# Access Compliance Report

## Public Rights-of-Way

### (Curb Ramps)

Intersection ID: 18778	Main Street: E_INDEPENDENCE_BV	Cross Street: E_W_T_HARRIS_BV	Location: W
ADA ID: 99E421C55C11	Ramp Type: IslandPerp	Initial Pass/Fail: Pass	Overall Compliance: No
		Severity Score: 2.5

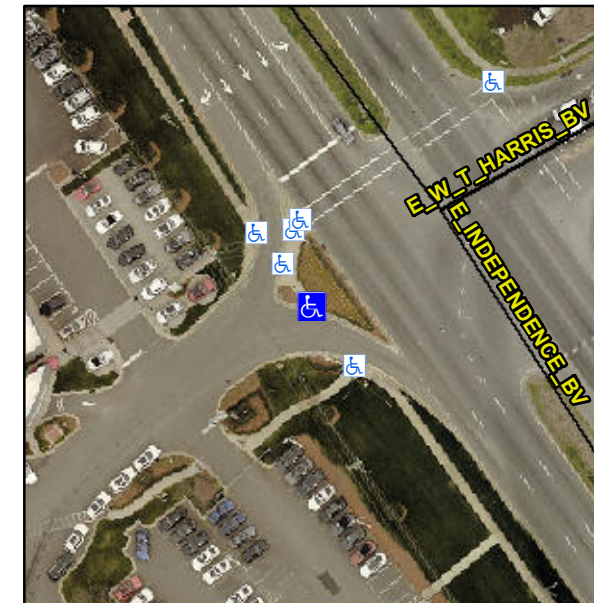
**Remove & Replace Entire Ramp.**

**Not Found, R304.2.2-Perp, R304.3.2-Para, R305.1.4, R305.2, R302.7**
